APPEAL SUMMARY

Appeal ID: 24537	Project Address: 546 NE 12th Ave
Hearing Date: 1/20/21	Appellant Name: Joe Echeverri
Case No.: B-009	Appellant Phone: 9714201120
Appeal Type: Building	Plans Examiner/Inspector: John Cooley, Nate Takara
Project Type: commercial	Stories: 2 Occupancy: A-1, A-2, A-3, A-4, B, E Construction Type: II-B, III-B, II-A
Building/Business Name: Benson Polytechnic High School	Fire Sprinklers: Yes - NFPA 13 throughout
Appeal Involves: Erection of a new structure, Alteration of an existing structure, Reconsideration of appeal	LUR or Permit Application No.:
Plan Submitted Option: pdf [File 1] [File 2]	Proposed use: High School

Portland Public Schools
**BENSON
POLYTECHNIC
HIGH SCHOOL
MODERNIZATION**

546 NE 12th Ave, Portland, OR 97232

Historic Administration Guard wall and Handrail section

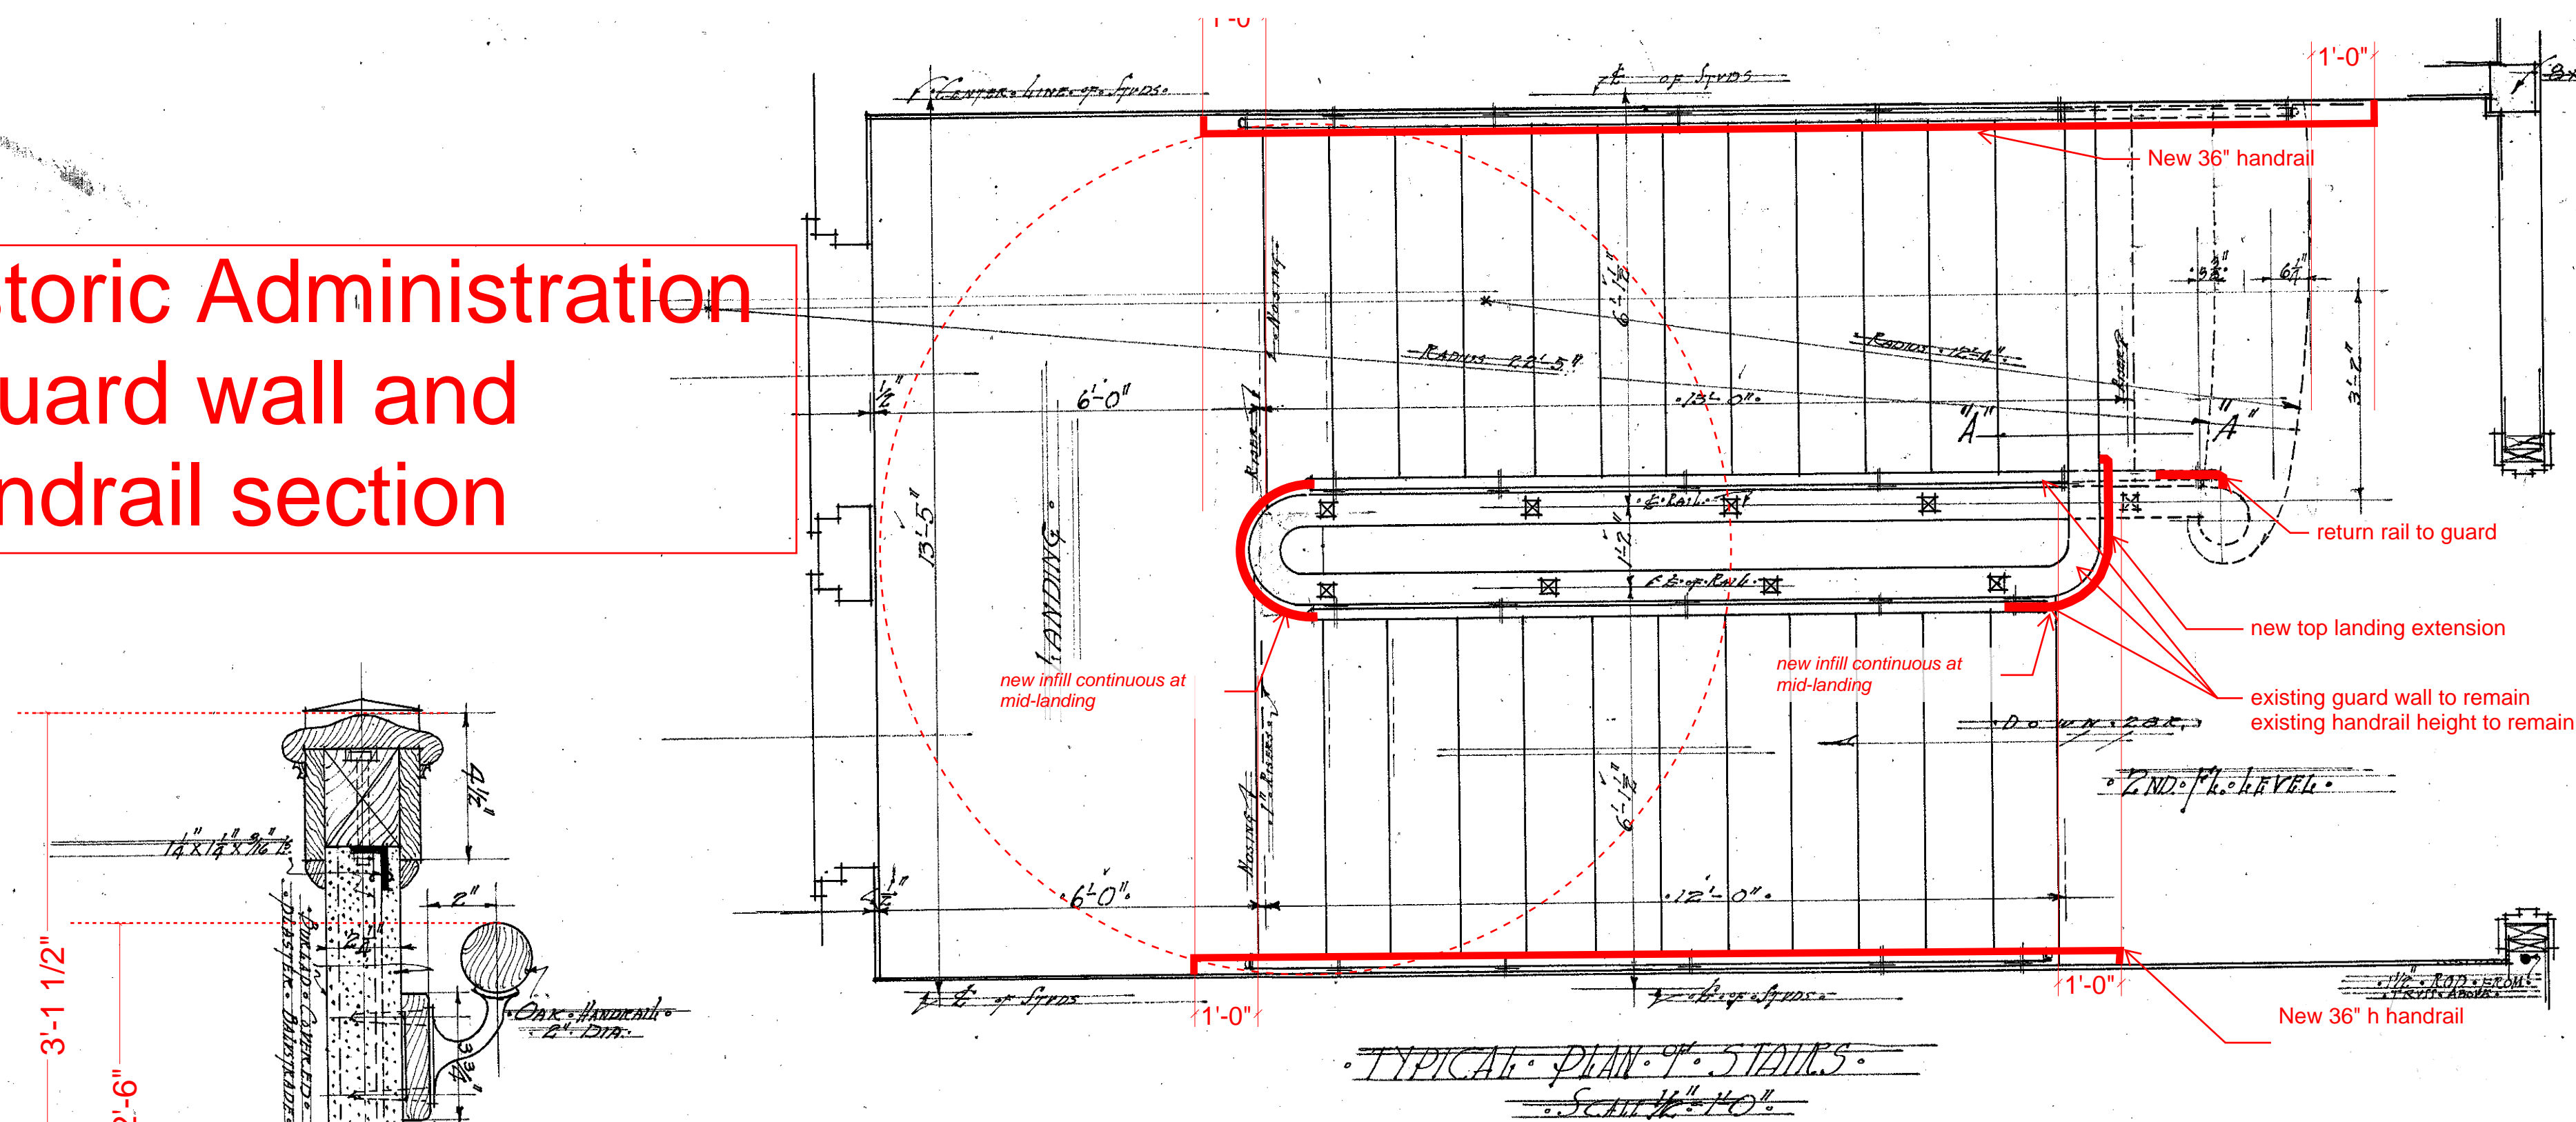
See exhibit pages SK2, SK3 and SK4 for rail heights, terminations, and continuity.

- Intermediate handrail height as-built 30" aff to remain.
- Install new perimeter wall handrail at 34 – 38" aff height.

- Intermediate handrail: Bottom terminate into guard less than 11". Top extend and wrap guard min 11"
- New perimeter wall handrail: Bottom and top extensions min 11" in direction of travel.

- Install tempered safety glazing at existing transom lights.
- Install quick response sprinkler heads within 12 inches of each side of glazed clerestory frame for water curtain coverage Levels 1 and 2.
- Level 2 hallway walls terminate at underside of ceiling as - built.

Locations: As indicated in initial appeal except Auditorium (Bldg. A) Delete Stair 4 guard. See SK2, SK3 and SK4 for historic building guard heights and details.

- 1. Reduction in minimum number of required plumbing fixtures: Granted as proposed.**
- 2. Existing handrail conditions to remain: Granted as proposed.**
- 3. Existing exit access stair configurations to remain with addition of quick response sprinkler heads: Granted as proposed.**
Note: Appeal also grants interior exit stairs 10 and 12 with quick response sprinkler protection on both sides of glazed walls. A separate permit from the Fire Marshal's Office is required.
- 4. Use of rail mounted ADA inclined platform stair lift for accessible route to two Level 2 classrooms at West side of Gymnasium: Granted as proposed with reduced stair width while lift is in operation.**
- 5. Omission of barrier where stairs continue below level of exit discharge: Granted as proposed.**
- 6. Allow existing historic guard rail heights to remain as built: Granted as proposed.**
